**Application For Reissue of
U.S. Patent No. 6,000,374**

For: MULTI-CYCLE, ENGINE BRAKING WITH POSITIVE POWER VALVE
ACTUATION CONTROL SYSTEM AND PROCESS FOR USING THE
SAME

Preliminary Amendment in Reissue Application

Request for Approval of Drawing Changes

FIG. 12
AMENDED

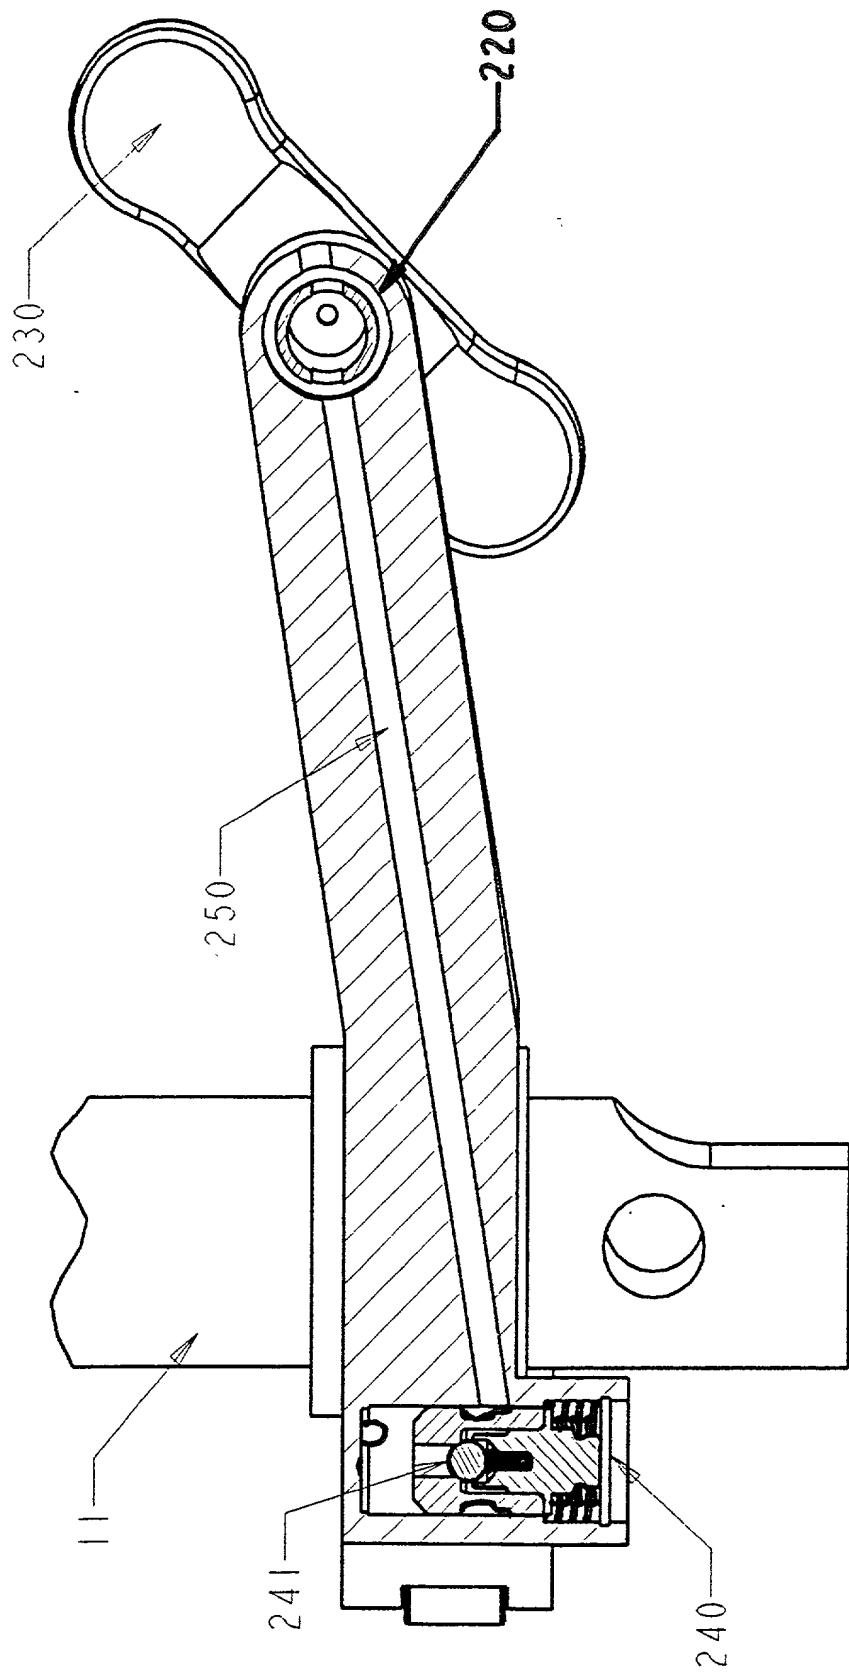
Fig. 12 is a cross-sectional view of [the] an intake rocker arm [of Fig. 11 along section line VII-VII] according to one embodiment of the present invention;

Means for effecting intake valve operation will now be described in connection with Figs. [10-12] 11 and 12. The means includes an intake rocker arm 200 that is rotatably mounted on the common rocker shaft 11. A first end of the intake rocker arm 200 may include an intake cam lobe follower 210, as described above in connection with exhaust rocker arm 100. The intake roller follower 211 of the intake cam lobe follower 210 is in contact with the intake cam lobe 22. However, it is contemplated that other cam followers[, such as, for example, a roller follower] are considered to be within the scope of the present invention.

FIG. 14

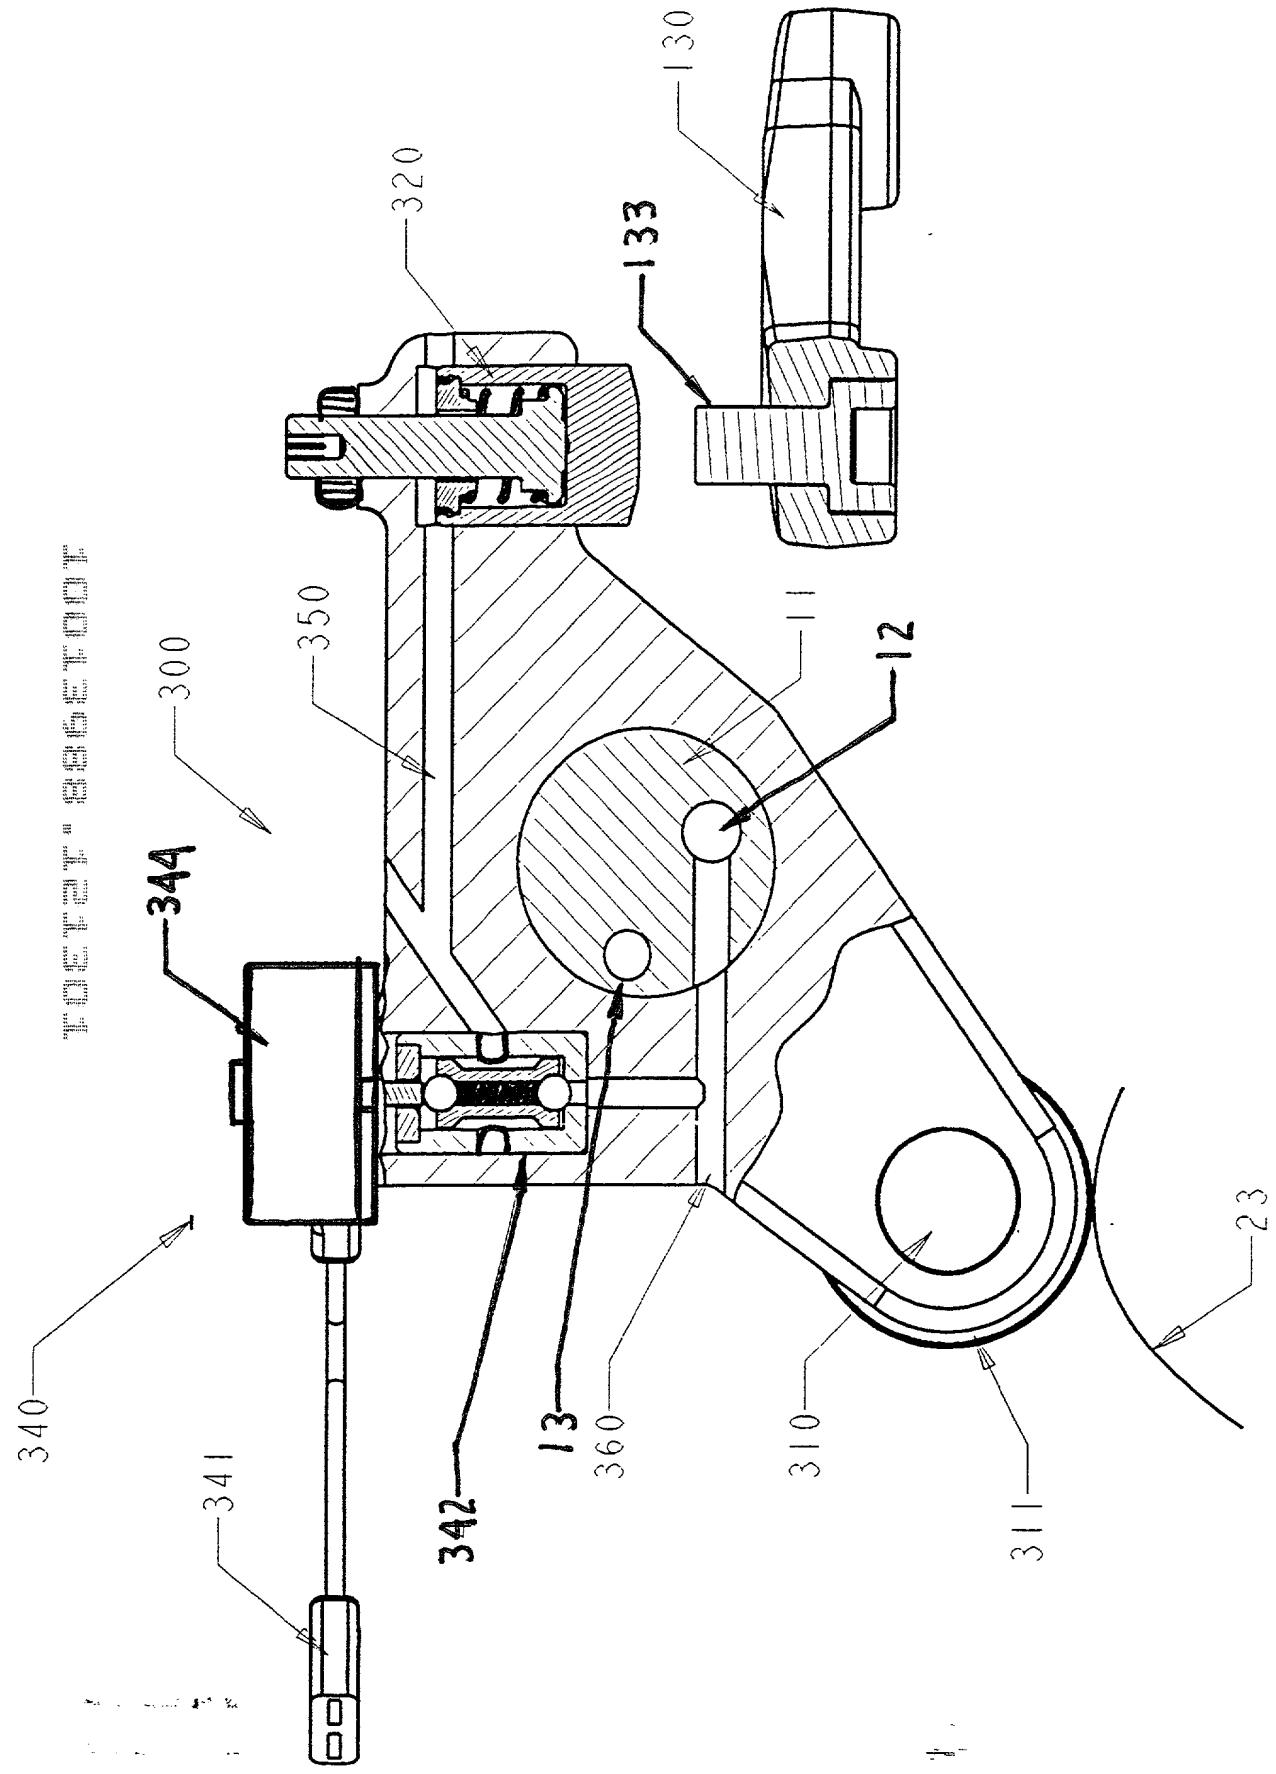
Fig. 14 is a partial cross-sectional view of [the] a brake rocker arm [of Fig. 13 along section line VIII-VIII] according to one embodiment of the present invention;

Means for effecting two cycle engine braking will now be described in connection with [Figs. 13-15] Fig. 14. The means includes a brake rocker arm 300 that is rotatably mounted on the common rocker shaft 11. A first end of the brake rocker arm 300 includes a brake cam lobe follower 310. The brake cam lobe follower 310 preferably includes a roller follower 311 that is in contact with the brake cam lobe 31.

The operation of the brake rocker arm **300** during positive power operation will now be described. The [solenoid] valve **340** is closed. During positive power, the solenoid valve **344** of the valve **340** remains closed. Accordingly, the actuator piston **320** remains in a [seated] retracted position, as shown in [Figs. 14 and 15] Fig. 14. The brake rocker arm **300** will remain in a disabled position during positive power.

FIG. 18 AMENDED

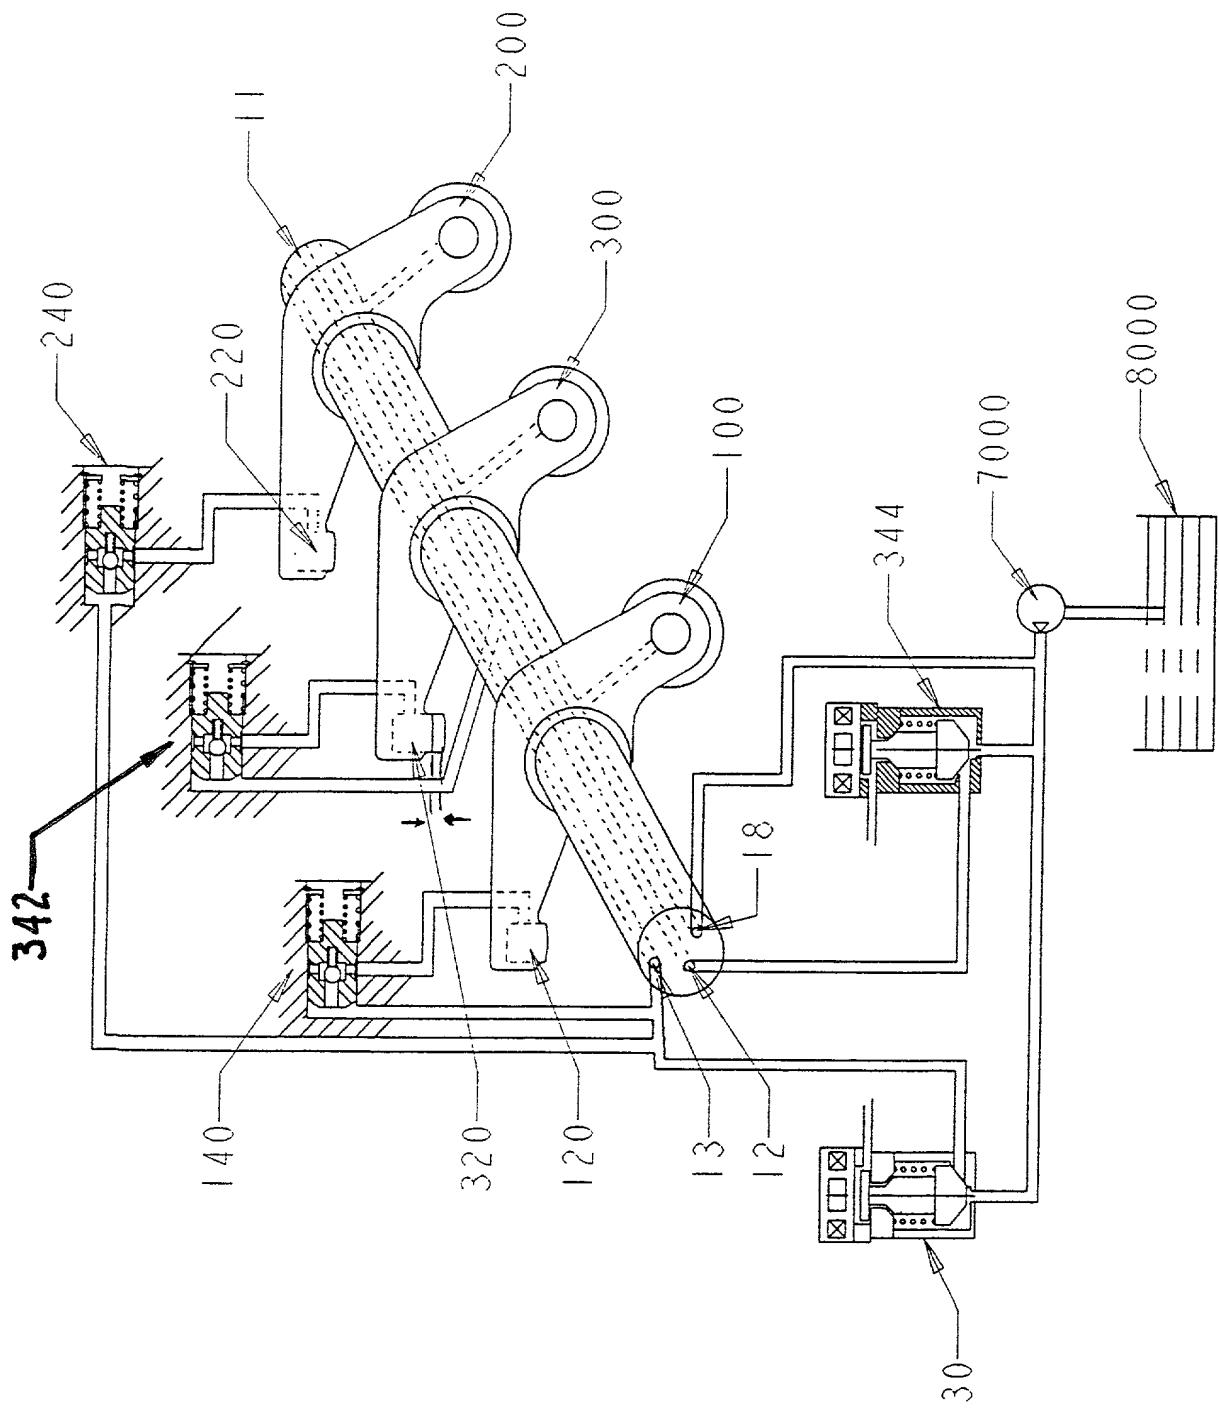
Reference will now be made in detail to a preferred embodiment of the present invention, an example of which is illustrated in the accompanying drawings. Fig. 4 and Fig. 18 illustrate a schematic view of the valve side of [dual cam shaft] a rocker arm arrangement and dedicated brake cam rocker for a compression release-type engine brake assembly **10** according to the present invention. The compression release engine brake components and the valve actuation components are located in rocker arms **100, 200, and 300**.

The passage 12 is connected to passage [15] 16 which supplies hydraulic fluid to provide lubrication between the [exhaust] intake rocker arm 200 and the common rocker shaft 11. The passage [14] 16 also supplies lubricant through passage [17] 25 to the [exhaust] intake cam lobe follower 210 such that the intake roller follower 211 [smoothly follows cam 22] is lubricated. Alternatively, the common rocker shaft 11 may be provided with a third passage 18, as shown in Fig. 18. The third passage 18 supplies lubricant to the cam lobe [following] followers 110, 210 and 310.

NEW
FIG. 19

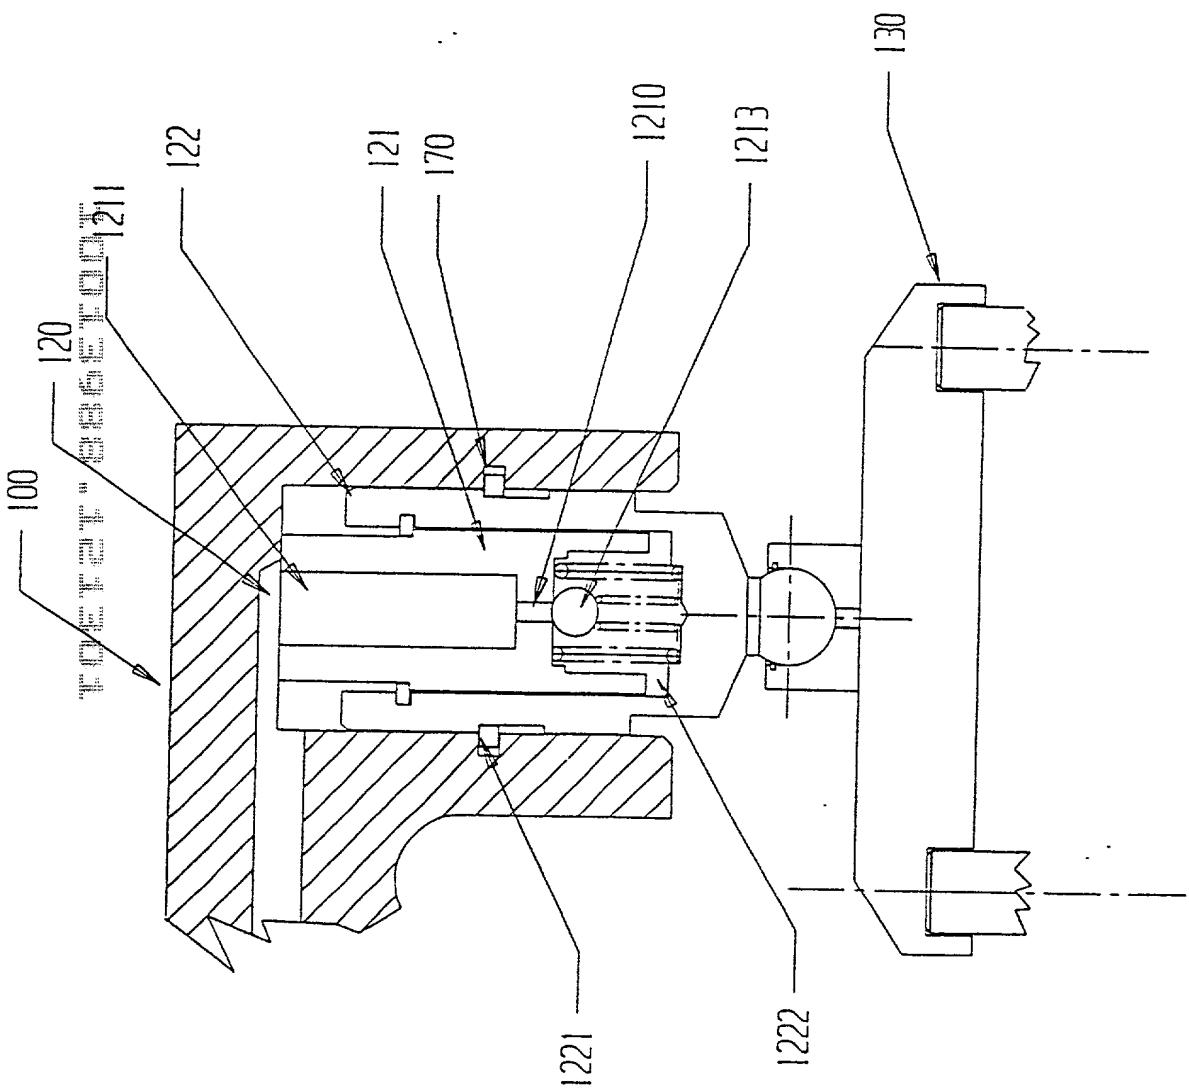
Fig. 19 is an enlarged cross-section view of a lash adjuster according to one embodiment of the present invention;

The lash adjuster **120** will now be described in connection with Fig. [9] 19. The lash adjuster **120** is mounted in the second end of the exhaust rocker arm **100**, as shown in Fig. [9] 19. The lash adjuster **120** includes an inner plunger **121** and an outer plunger **122**. The outer plunger **122** includes a ring **1221** that is positioned within groove **170** within the exhaust rocker arm **100**, as shown in Fig. [9] 19. The inner plunger **121** is slidably received within the outer plunger **122**. In operation, hydraulic fluid flows into a cavity **1211** in the inner plunger **121**. As the cavity **1211** fills with fluid, the check ball valve **1213** is biased downwardly to open aperture **1210** in the inner plunger **121**. Hydraulic fluid then flows into cavity **1222** [in] between the outer plunger **122** and the inner plunger **121**. As the cavity **1222** is filled with fluid, the outer [piston] plunger **[121] 122** moves downward to an extended position to engage crosshead [pin] **130**. The downward movement of the outer [piston] plunger **[121] 122** is limited by the ring **1221** engaging the lower surface of groove **170**.

Fig. 20

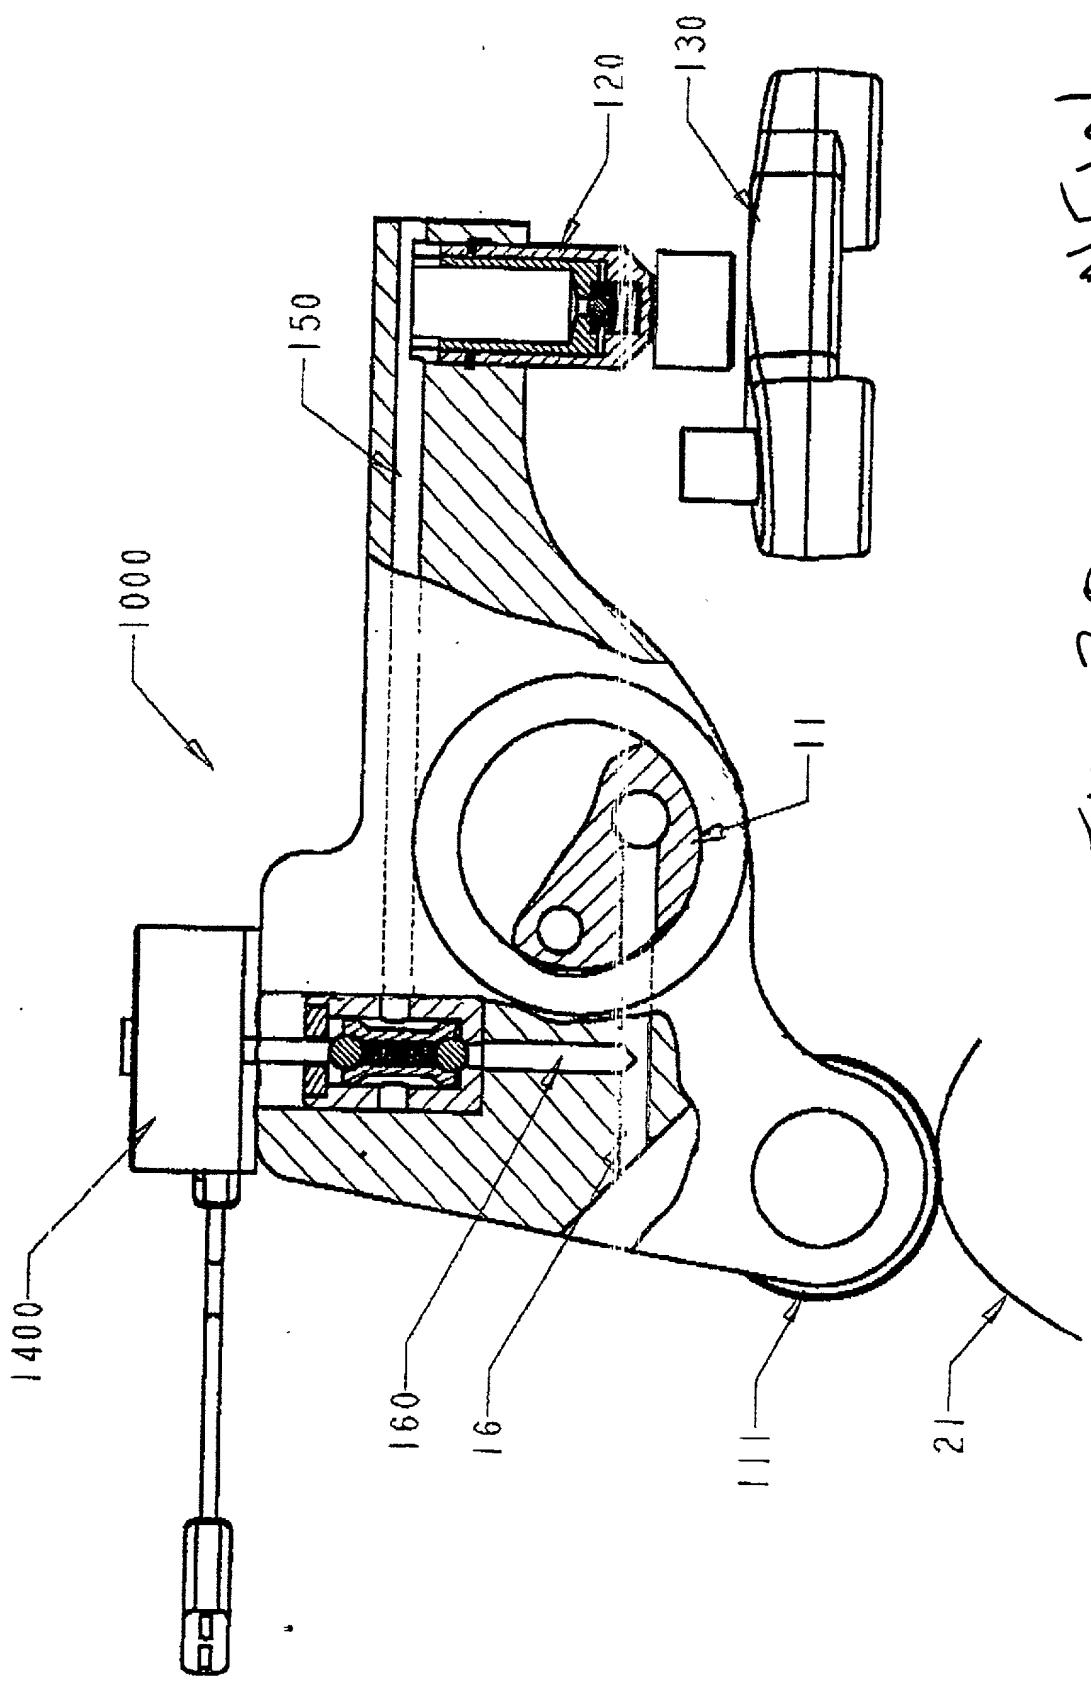
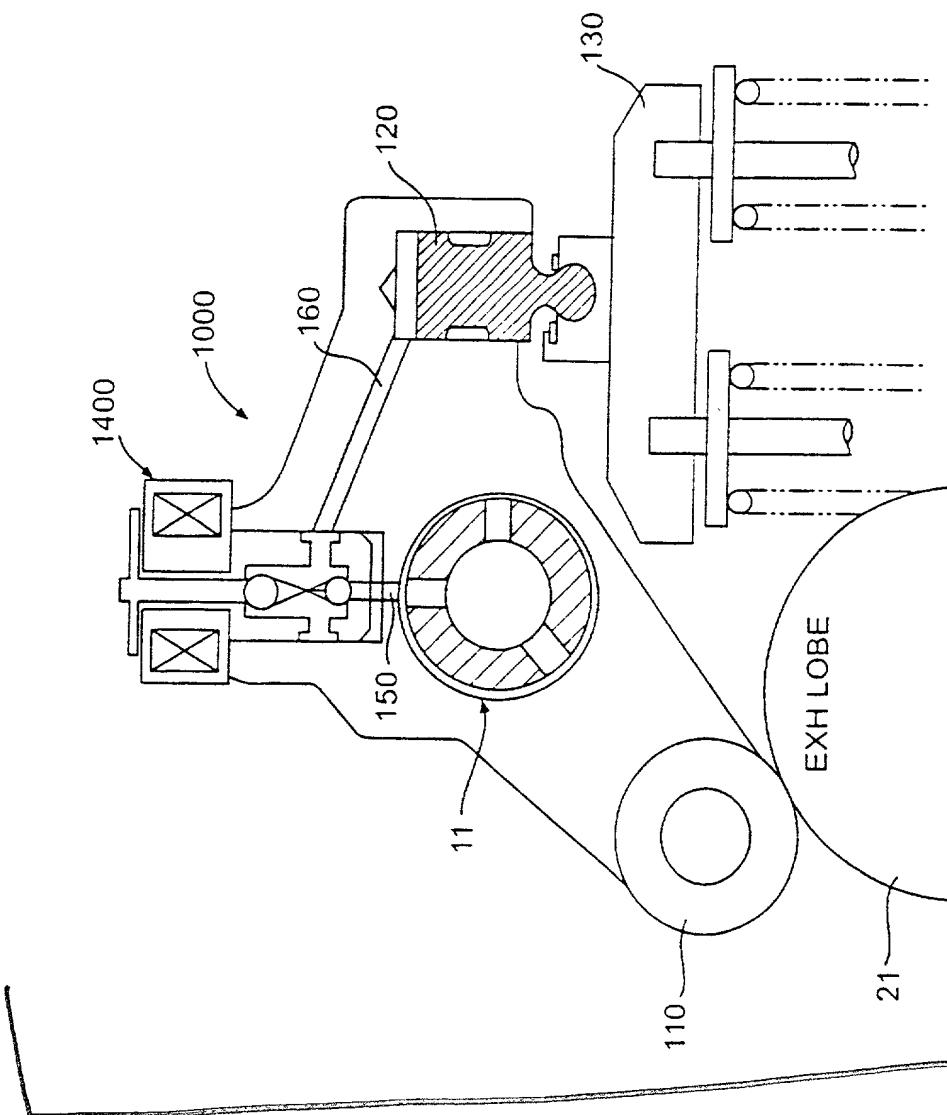
Fig. 20 is a side view of an exhaust rocker arm according to an alternate embodiment of the present invention; and

Continuing with the embodiments in the accompanying figures, Fig. [16] 20 is an alternative embodiment for the means for effecting exhaust valve operation. The exhaust rocker arm **1000** is rotatably mounted on the common rocker shaft **11**. A first end of the exhaust rocker arm **1000** includes an exhaust cam lobe follower [110] 111.

Pursuant to 37 CFR §§ 1.121 and 1.173, Applicants respectfully request approval of the changes indicated in red on the attached sheets for the above-referenced reissue application. The changes are necessary to correct errors inadvertently incorporated into the above-referenced original patent. In particular, Figs. 3, 4, 6, 7, 8, 11, 12, 14, and 18 are amended, Figs. 5, 9, 10, 13, 15, 16, and 17 are canceled, and Figs. 19-21 are added. Figure 19 corrects errors in, and in effect replaces, canceled Fig. 9. Figure 20 corrects errors in, and in effect replaces, canceled Fig. 16. Figure 21 corrects errors in, and in effect replaces, canceled Fig. 17.
